## Product Advisory

Issue Date: September 15, 2022

Whitney+ power reduction configuration support in 2.25

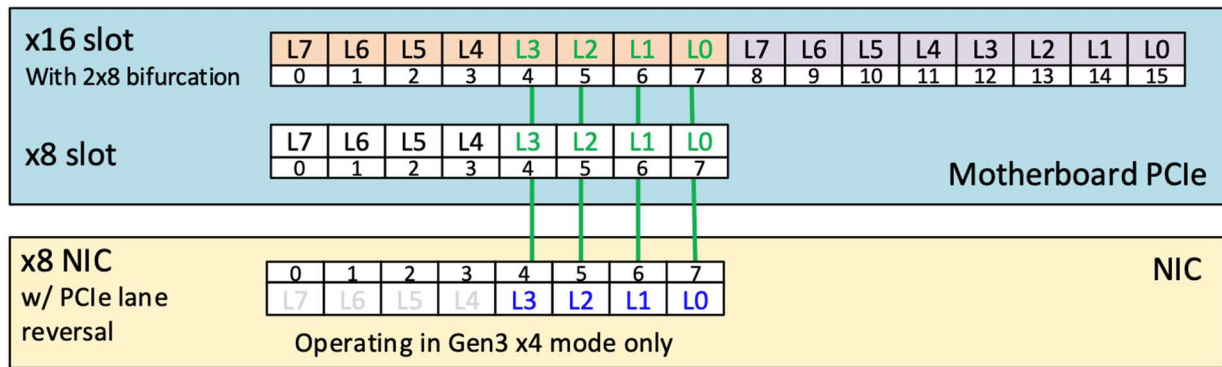
Above listed Broadcom NICs implement PCIe lane reversal (table 1) on the PCB, which may be incompatible with certain motherboards after enabling the power reduction feature. If the feature is enabled on an incompatible motherboard, **the card will not be detected by the host over the PCIe bus.**

Step1: A board listed in table 1 is updated or manufactured with a firmware release in table 2

Step2: Modify the corresponding NVM config item to enable the power reduction feature

Step3: An AC power cycle is required for the change to take effect

Step4: After the AC power cycle, the power reduction feature is enabled

The above sequence of events will result in the card not getting detected on incompatible motherboards. To recover the card, the customer will need to move the NIC card to a compatible system, disable the feature, and then move the card back to the original motherboard.

- Users must consult the FAE Advisory “Wh+ 10G Power Reduction Feature in 2.25 FW Release” to ensure system compatibility before enabling this feature.
- Customers should test the power reduction feature first before mass deploying the feature in the field for the NIC cards listed above.
- Follow the Firmware upgrade & downgrade considerations provided in the reference document.
